HISTORIC AND DESIGN REVIEW COMMISSION

November 18, 2020

HDRC CASE NO: 2020-485
ADDRESS: 909 N HACKBERRY ST
LEGAL DESCRIPTION: NCB 529 BLK 2 LOT N 92.5 FT OF 13 & 14
ZONING: IDZ-1, H
CITY COUNCIL DIST.: 2
DISTRICT: Dignowity Hill Historic District
APPLICANT: Michael Garansuay/GARANSUAY MICHAEL S & TERESA P
OWNER: Michael Garansuay/GARANSUAY MICHAEL S & TERESA P
TYPE OF WORK: Construction of four residential structures; two, 2-story residential structures and two, 1-story residential structures
APPLICATION RECEIVED: October 26, 2020
60-DAY REVIEW: Not applicable due to City Council Emergency Orders
CASE MANAGER: Edward Hall

REQUEST:

909 N HACKBERRY
ELEVATIONS

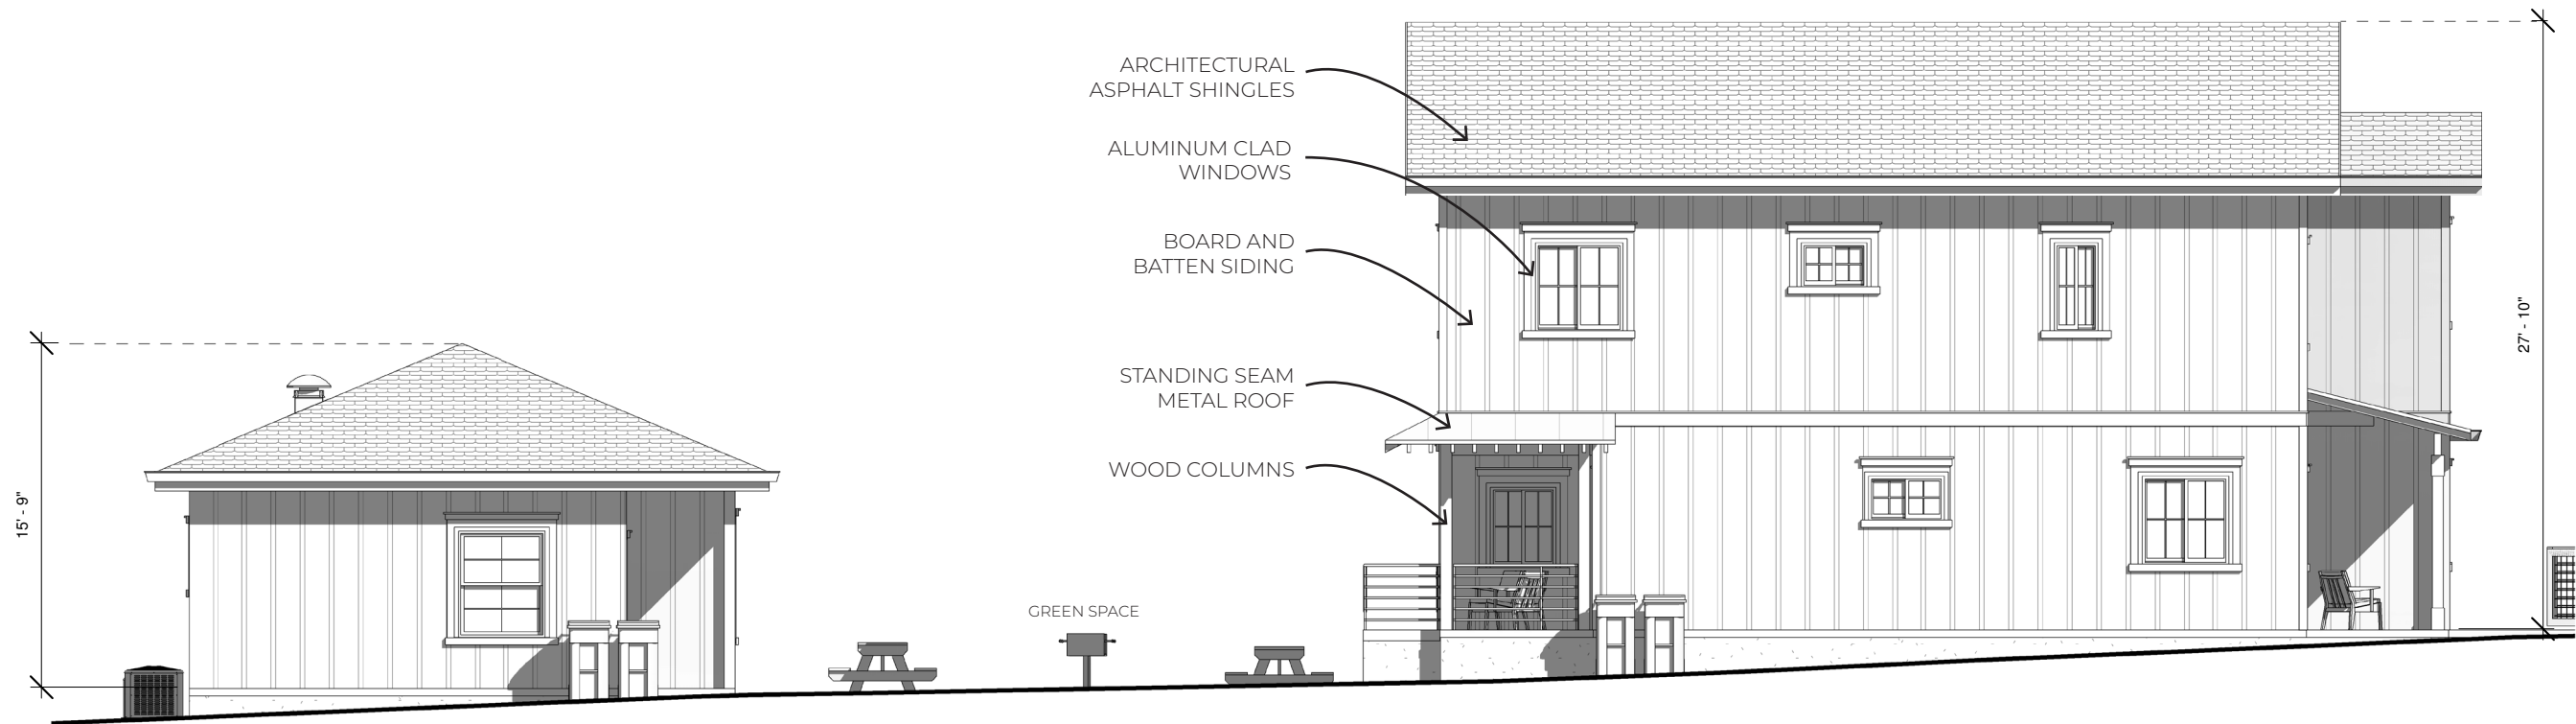
- g. **SCALE, MASS & HEIGHT** – Per the Guidelines for New Construction 2.A.i., a height and massing similar to historic structures in the vicinity of the proposed new construction should be used. In residential districts, the height and scale of new construction should not exceed that of the majority of historic buildings by more than one-story. As noted in finding c, this block features one story structures; however, there are 2-story historic structure in the vicinity, specifically one block to the north. The applicant has noted an overall height of approximately twenty-eight (28) feet in height. Additionally, the applicant has proposed widths that are

- h. **FOUNDATION & FLOOR HEIGHTS** – Per the Guidelines for New Construction 2.A.iii., applicants should align foundation and floor-to-floor heights within one foot of floor-to-floor heights on adjacent historic structures. Per the construction documents, the proposed new construction features a minimal foundation height on the front façade. Staff finds that the foundation height should be increased to present a foundation height from the front that is consistent with those found historically within the district.

- j. **WINDOW & DOOR OPENINGS** – Per the Guidelines for New Construction 2.C.i., window and door openings with similar proportions of wall to window space as typical with nearby historic facades should be incorporated into new construction. Generally, staff finds the proposed window openings to be atypical in size with those found historically within the district. Staff finds that window groupings, heights, and widths should be modified to be consistent with those found historically within the district.

- k. **PORCHES** – The applicant has proposed for both primary structures to feature both front and rear porches that are integral to the massing of both structures. Generally, staff finds the proposed porch depth and massing to be appropriate, as well as porch roof forms.

- i. That the setbacks of both primary structures on N Hackberry be increased to be greater than the setback on N Hackberry of the structure at 527 Hays, as noted in finding e.

- vi. That the applicant incorporate appropriate foundation heights as noted in finding h.

909 N HACKBERRY
ELEVATIONS

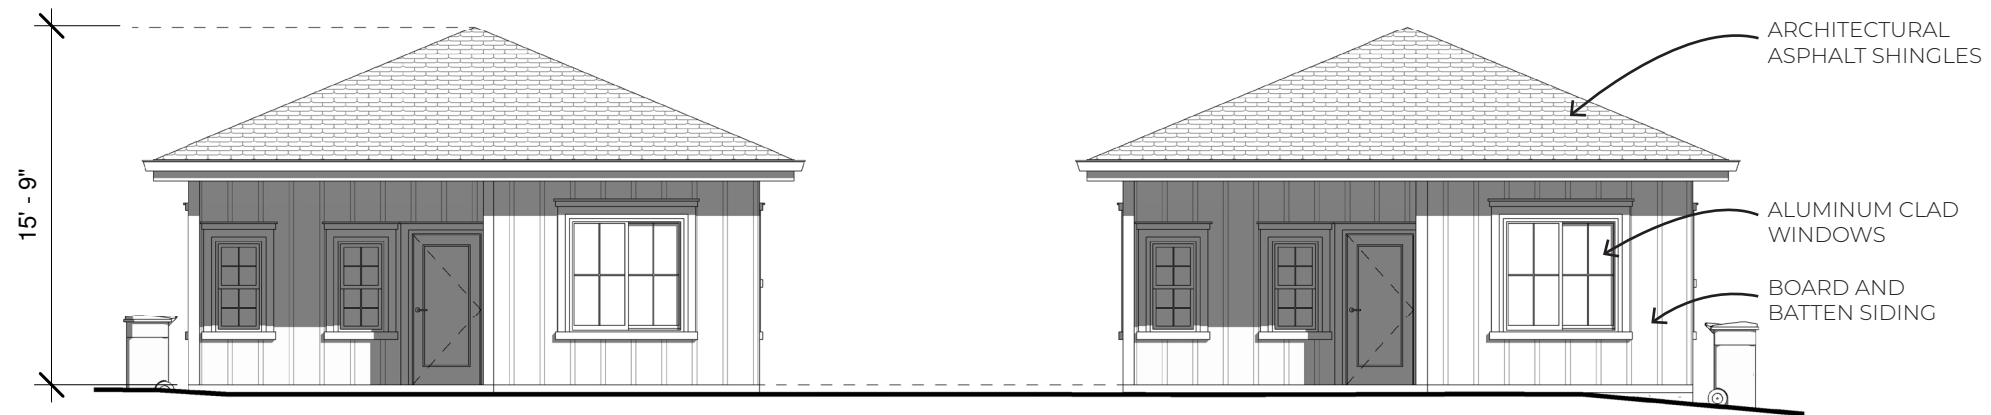
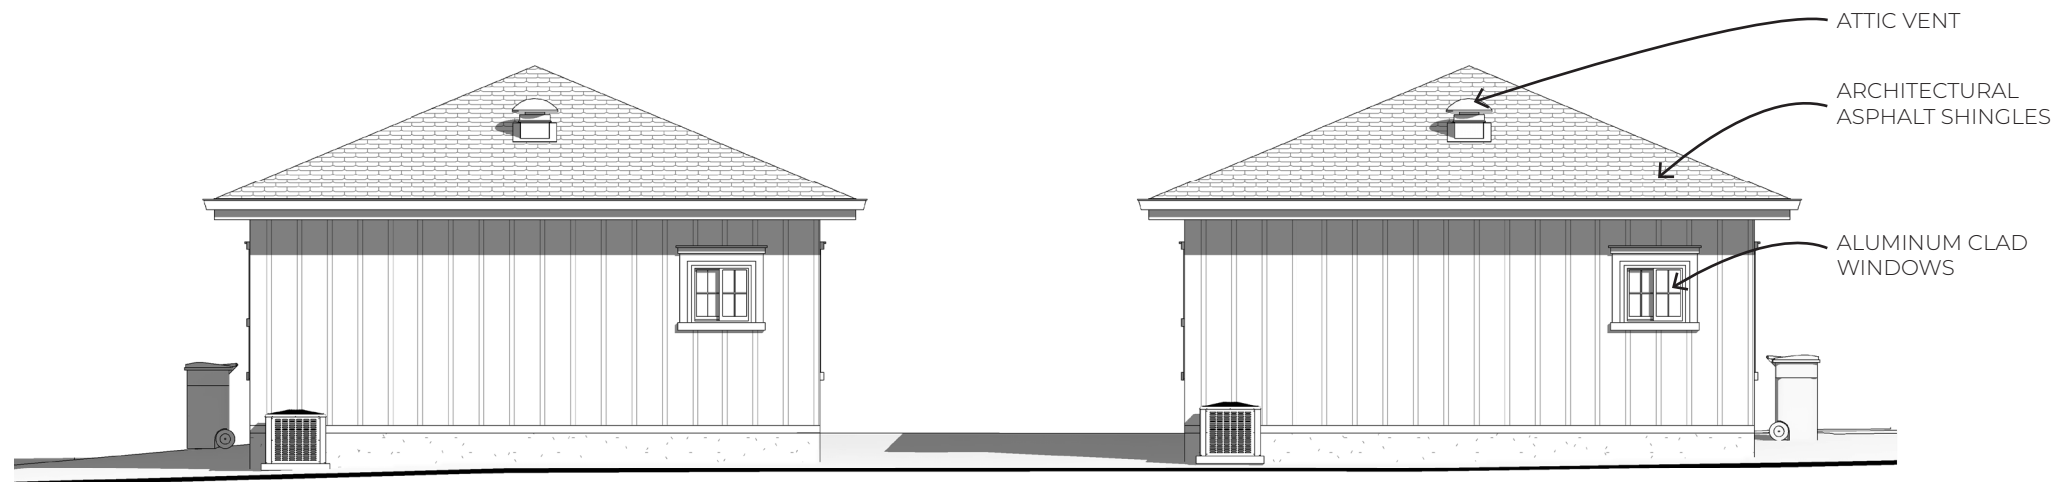
- u. **REAR ACCESSORY STRUCTURES** – The applicant has proposed to construct two, 1-story residential structures on the west side of the lot at the rear of the two, 2-story primary structures. The proposed structures are to feature 559 square feet each. The Guidelines for New Construction 5.A. notes that accessory structures should be designed to be visually subordinate to the principal structures in terms of their height, massing and form; should be no larger in plan than forty (40) percent of the primary structure's footprint; should feature complementary materials and simplified architectural details; and should feature similar window and door openings. Generally, staff finds the proposed rear structures to be consistent with the Guidelines.

- w. **MATERIALS (Accessory Structures) – MATERIALS** – The applicant has proposed materials that include asphalt shingle roofs, board and batten siding, fish scale/scalloped siding, and wood columns. Staff finds that metal roofs should feature panels that are 18 to 21 inches wide, seams that are 1 to 2 inches in height, a standard galvalume finish and a crimped ridge seam or a low profile ridge cap. If a ridge cap is used, it must be reviewed and approved prior to installation. Board and batten siding should feature a smooth finish, boards that are 12 inches wide and battens that are approximately 2 inches in width. Columns should be six inches square and feature capital and base trim as well as chamfered corners.

- x. **WINDOW MATERIALS (Accessory Structures)** – The applicant has noted the installation of aluminum clad wood windows. Staff finds this to be appropriate; however, the proposed windows should adhere to staff standards for windows in new construction, as noted in the applicable citations.

- v. That the proposed windows adhere to staff's standards for windows in new construction as noted in findings o and x, and as noted in the applicable citations.
